Re: Mediterranean Village Review - #14153
Traffic Impact Study, Parking Analysis & Valet Operations Analysis

David Plummer and Associates (DPA) have completed several reviews of the Traffic Impact Analysis, Shared Parking Analysis, Parking Garage, and Valet Operation Analysis conducted for the proposed Mediterranean Village project. A summary of these components is below.

HOTEL DROP-OFF - OPTION #2 “OWNERS RECOMMENDATION”

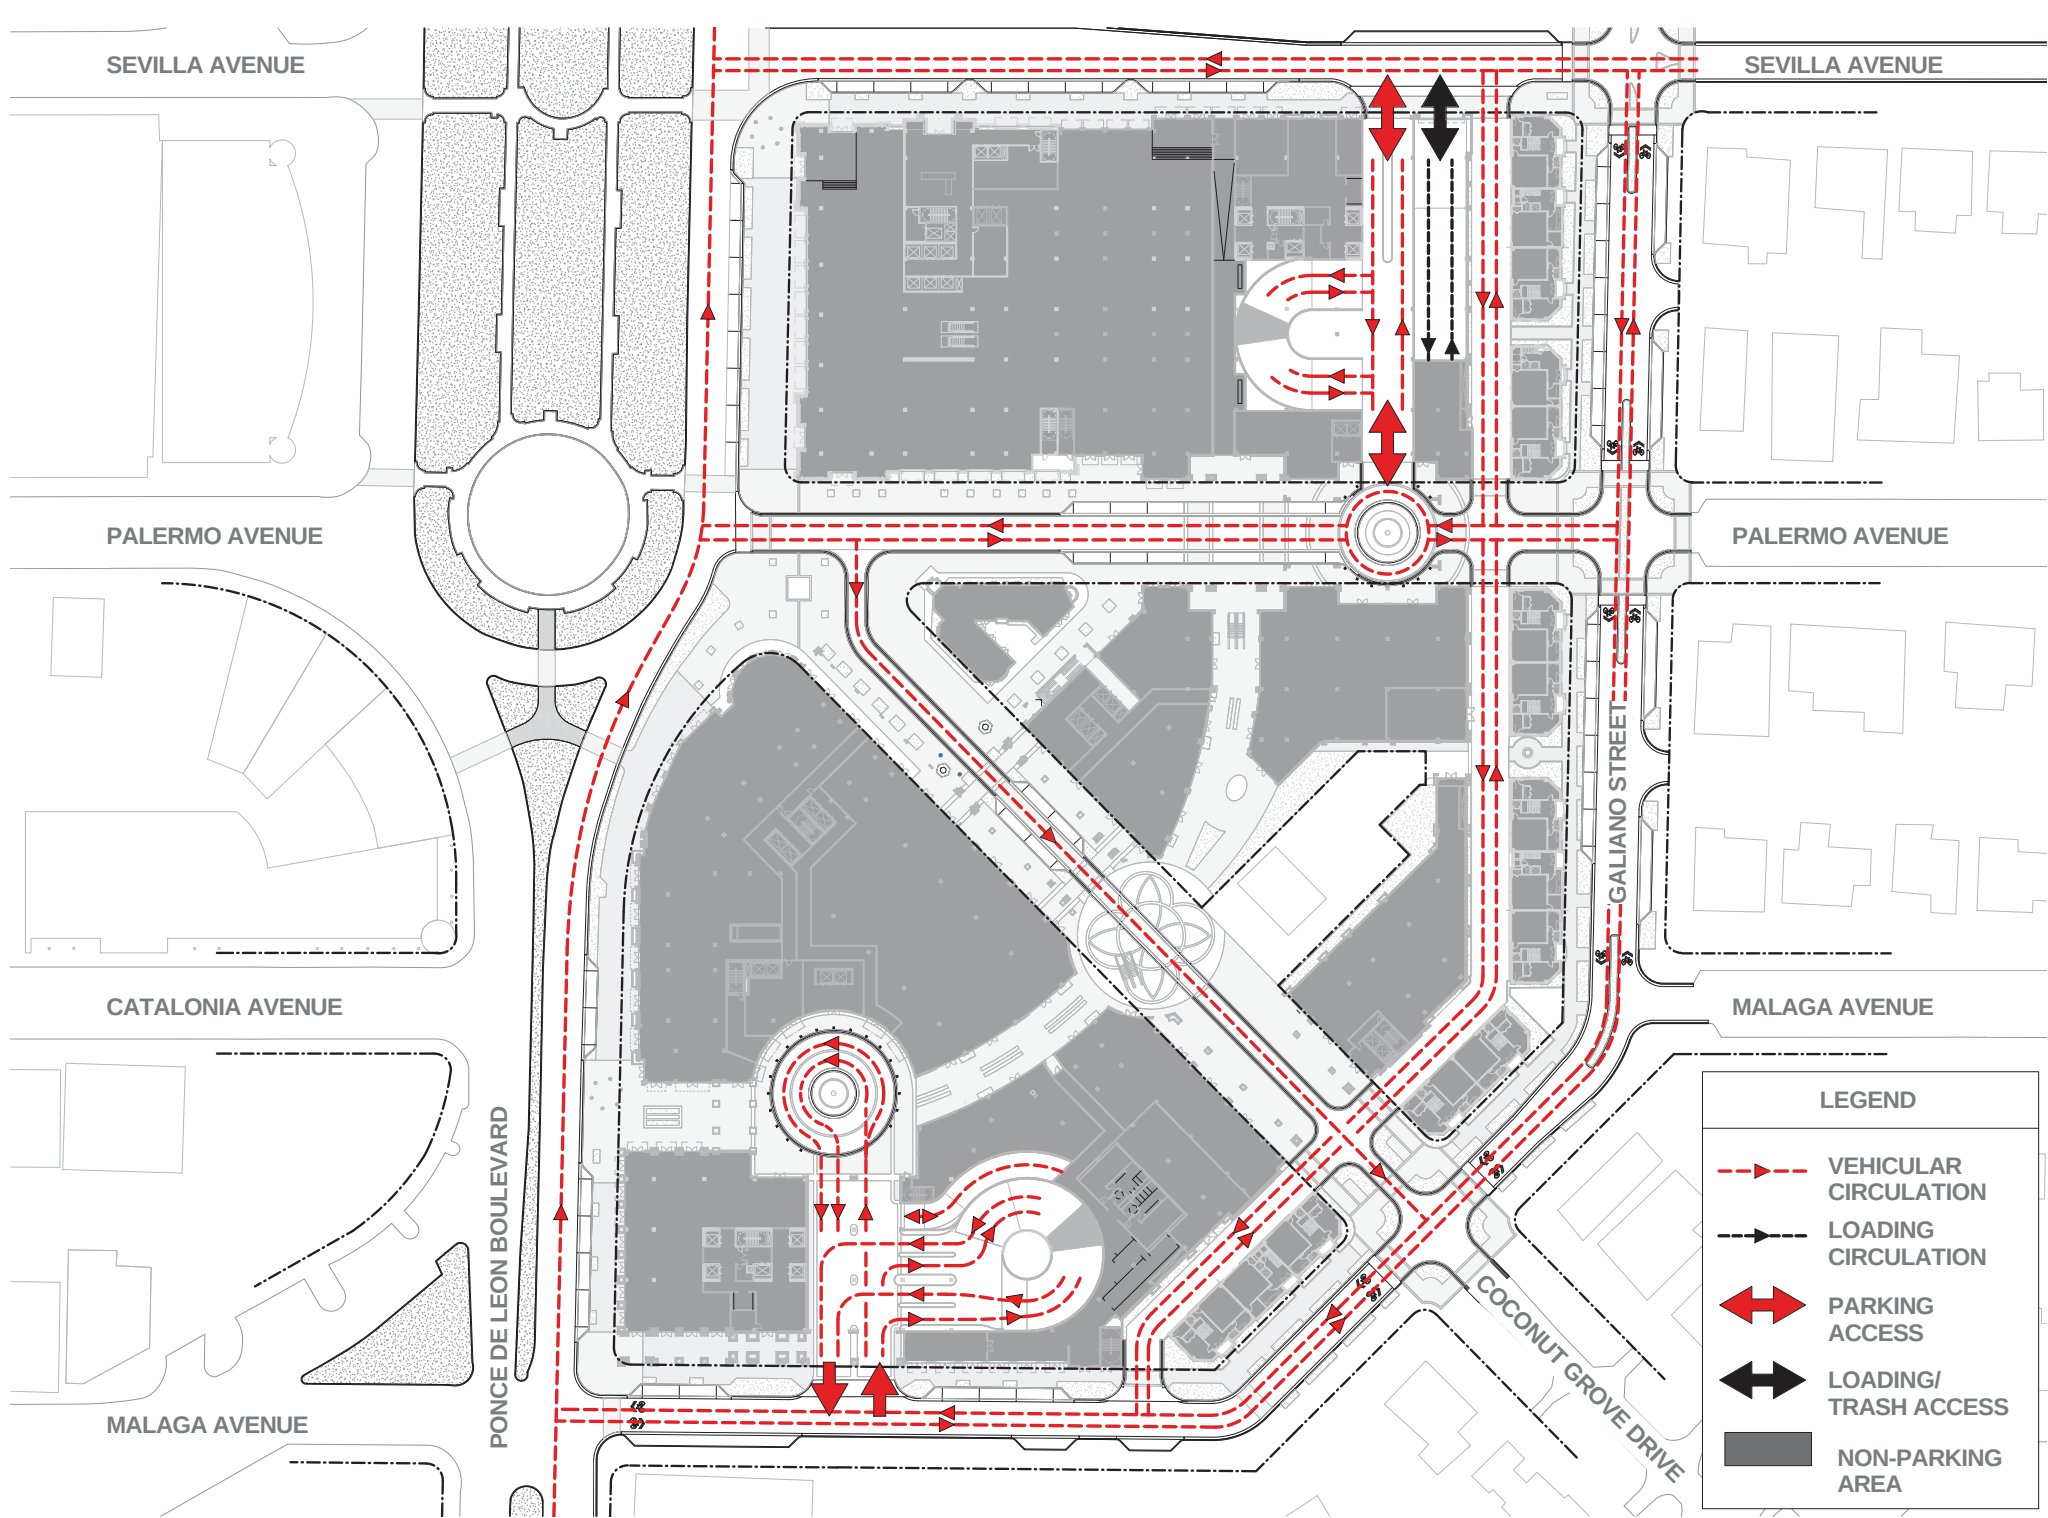
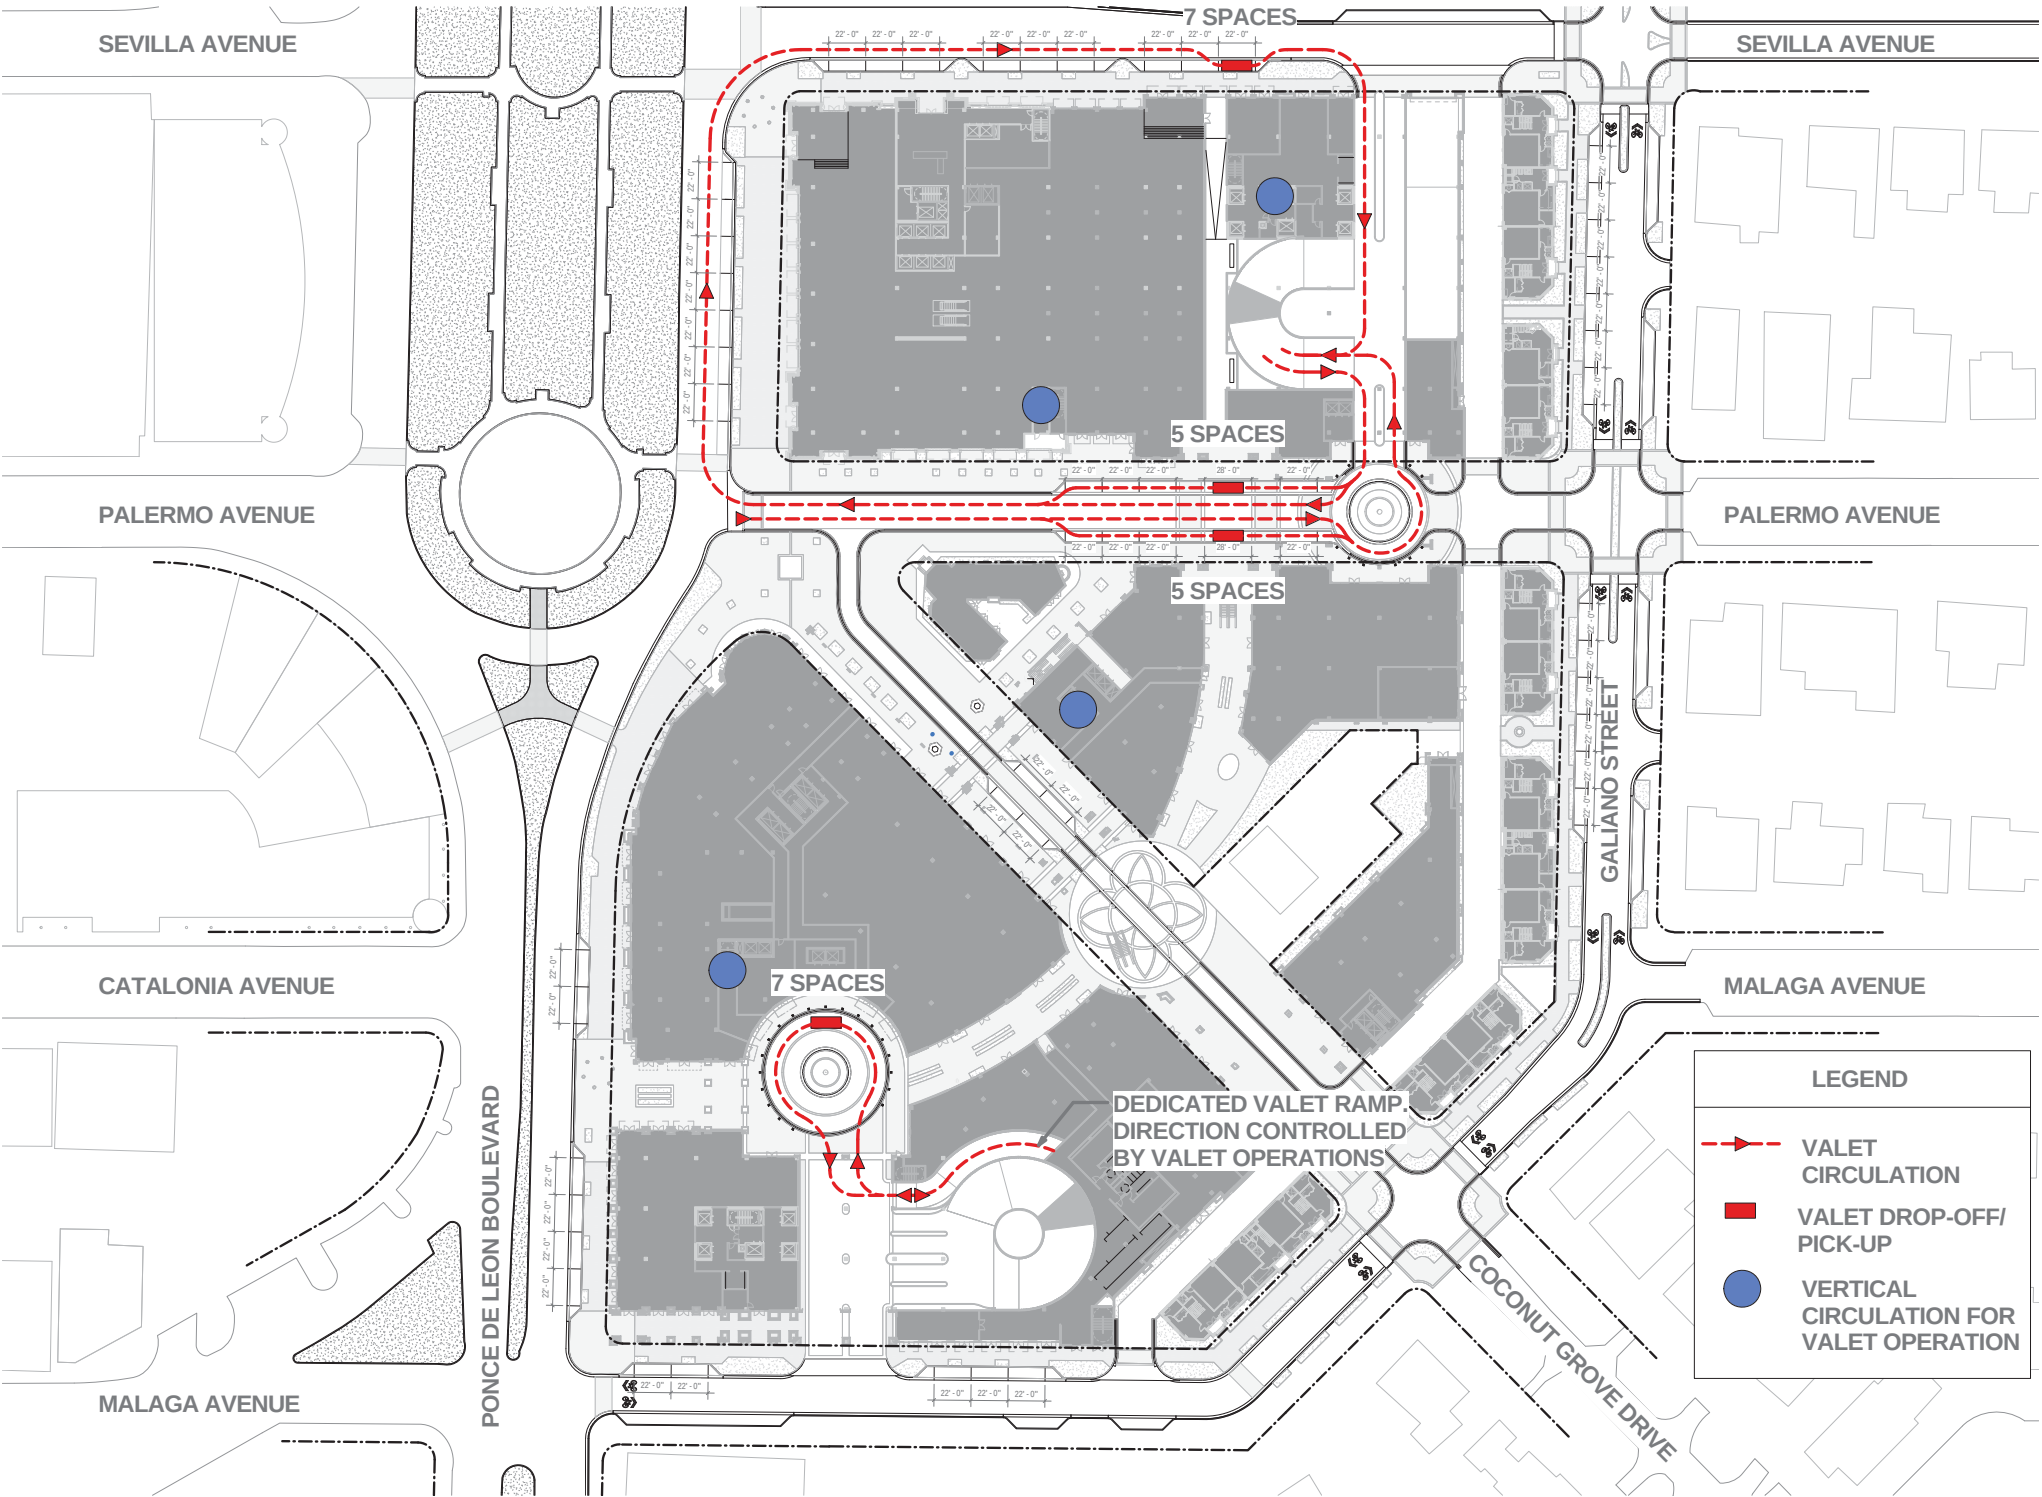
During first reading, the project included direct access to the hotel from Ponce. This access plan for the hotel was acceptable. The project has since changed to address comments from the Commission. Of the newly proposed options, Option 3 is an acceptable alternative and preferable to Option 2 provided that the following conditions are included: 1) the hotel valet ramps will be completely segregated from the Malaga driveway ramping system and no traffic from Malaga would be allowed to access the hotel's porte cochere, and 2) two one-way ramps (similar to the Ponce alternative) or a two-way, two-lane ramp for hotel valet use only is provided. See attachments for hotel access options.
